2006 - 2009 Cadillac XLR: Service Bulletin: #PI0299: Harsh Shifts After Replacement of 1-2-3-4 / 3-5-R Clutch Housing

#PI0299: Harsh Shifts After Replacement of 1-2-3-4 / 3-5-R Clutch Housing - (Nov 16, 2010)

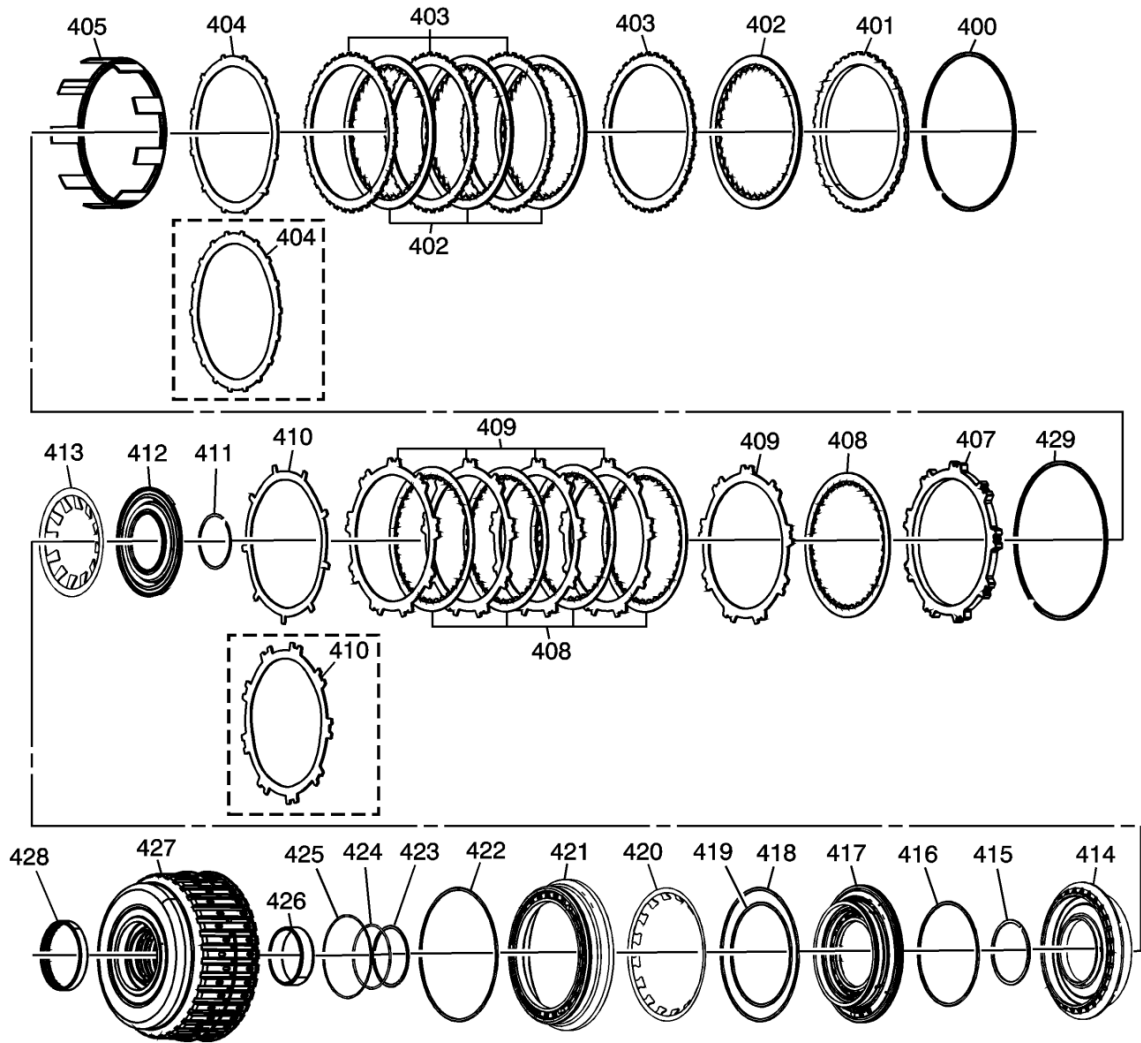
Some customers may comment on harsh shifts after replacement of the 1-2-3-4 / 3-5-R clutch housing (427).

This condition may be caused if the 1-2-3-4 / 3-5-R bearing (428) is not installed into the housing (427). The 1-2-3-4 / 3-5-R clutch housing is currently serviced through parts without this bearing installed and failure to order and install this bearing may result in harsh shifts. Plans are being implemented to service this housing as a kit that will include the bearing.

Note: The parts catalog calls out to order the bearing when the housing is also replaced.
